## **EUROPA GLIDER WING SPAR REINFORCEMENT**

1. **Classification:** **Mandatory**
2. **Applicability:** **Europa Motor Gliders**

## Mod 78 - Europa MG Wing Spar Tang Reinforcement

**Fig 6: Carbon Rope Splicing Geometry**

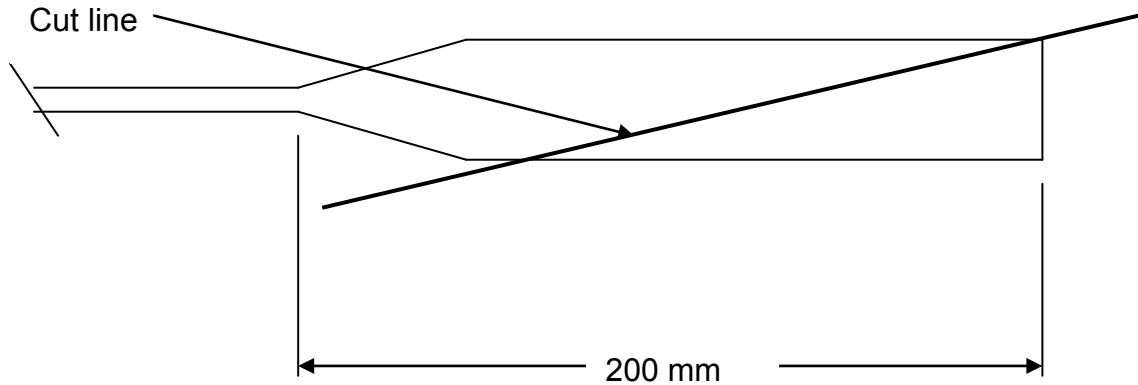
Each end of the carbon ropes thus produced is spliced by flattening the rope and cutting the end as shown below.

**Fig 7: Carbon Rope Lay-up Showing Tapered Void to be Filled**

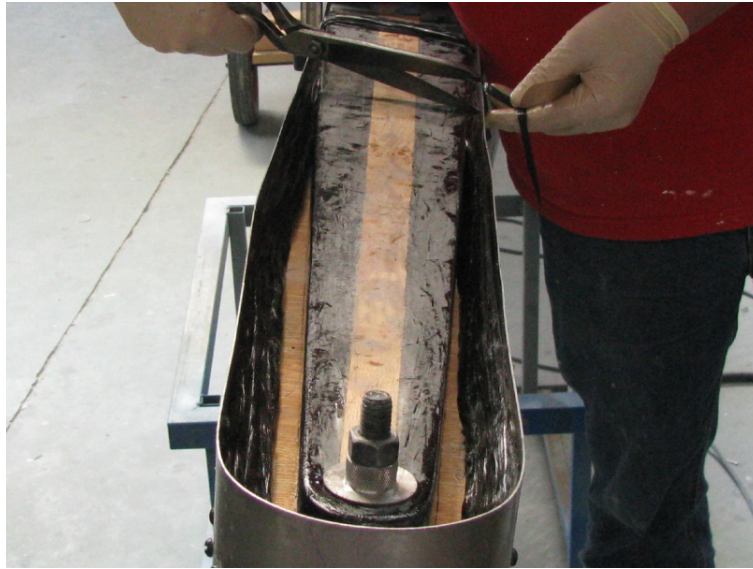
Lay successive ropes into the mould until the space between the mould tool edge and the spar is filled – the length of each rope being determined by the operative in order to completely fill the space in the mould. The length of successive carbon ropes required will become shorter but each one must be spliced at each end as shown above. The end of each spliced rope will progressively move further away from the root rib. Slicing each end of every carbon rope will ensure a smooth transition between the original spar and the wet rovings.

**Fig 9: Carbon Rope Lay-up Complete and Intensifier Board in Position**

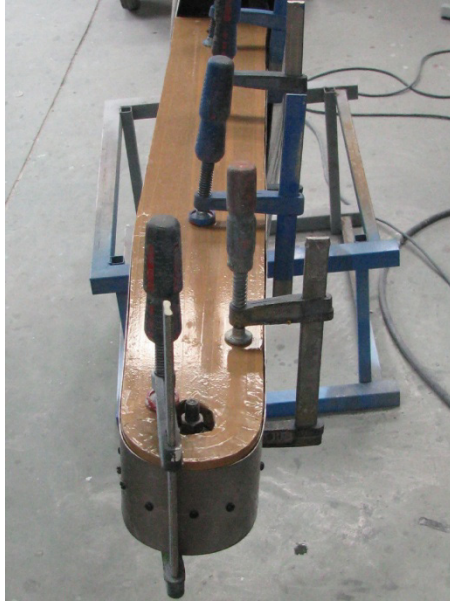
The carbon ropes should be packed in quite tight and should be level with the spar tang width when complete. Once the carbon ropes are smoothly pressed into place using a tongue depressor or spatula tool, clamp the intensifier board onto the spar to squeeze it all together. Allow to cure for 24 hours. Once cured, remove the intensifier and mould tool and inspect the layup for any voids. Ensure the final layup is not proud of the existing spar width

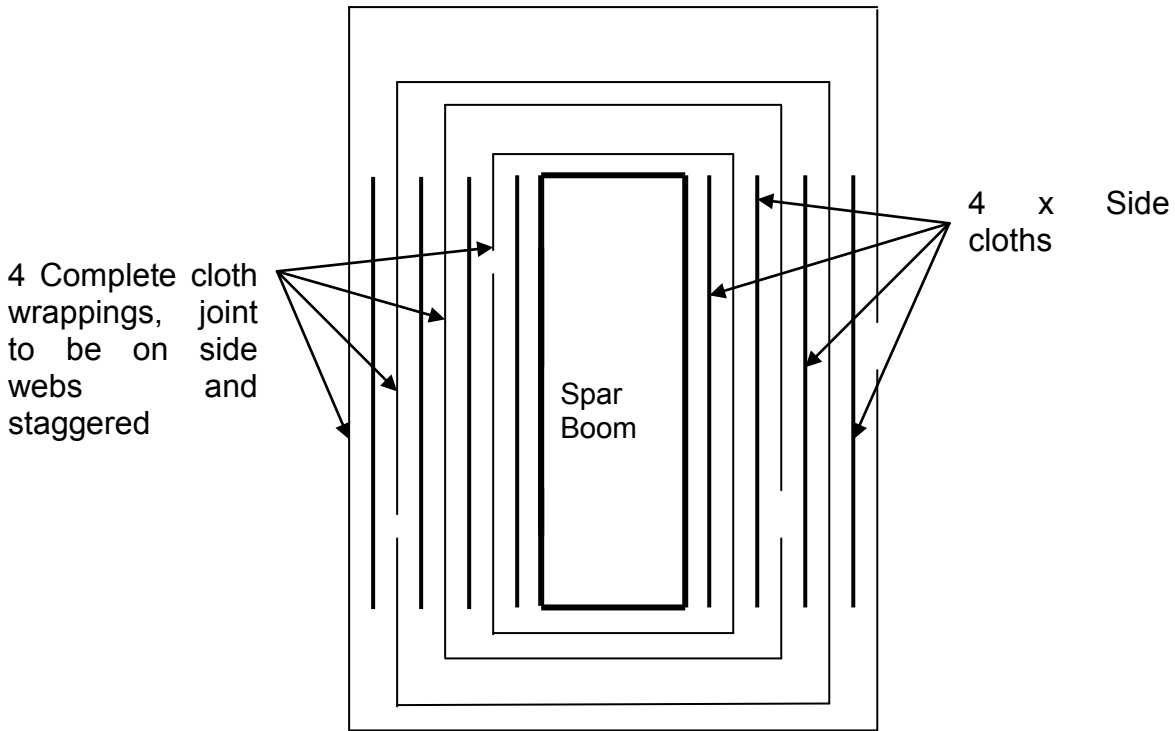
Lay-up one layer of carbon fibre cloth on each side of the boom. The fibre direction should be at +/- 45° to the boom centre-line. This is best achieved by previously cutting the strips of carbon at 45° from the full roll of cloth. Apply a second layer starting at the top edge of the spar boom and wrap it completely around the spar to butt up to the start point of the cloth. Repeat this procedure until there is a total of 8 layers on each side of the spar with four layers covering the top and bottom spar boom surfaces. Stagger the positions of the joints as shown below. **Do not overlap the joints as this may cause a build up of thickness on the two side webs.**

**Fig 12: Truncated Starboard Spar Tang after Cloth Lay-up  
(Note: The peel ply has still to be removed in this picture but the tip hole has been located.)**

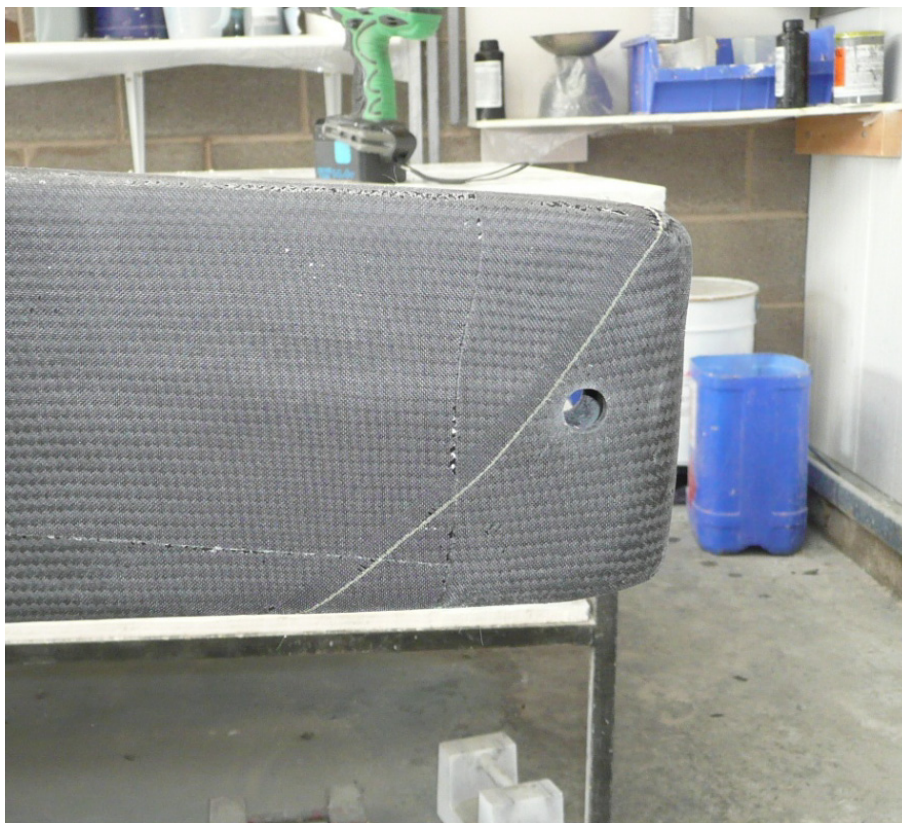
Open up the hole through the spar and rebond the tip spar bushes, GS12 and GS13, in place using Araldite 420 as described on page 8-7 of the glider build manual. The carbon cloth covering the tip hole position should sag into the hole clearly identifying where the hole is. Drill a small ¼ " dia exploratory hole through the cloth and open up the hole with a file. Note: this operation is only applicable if the wing has already been fitted. i.e. If the wing has already been fitted.
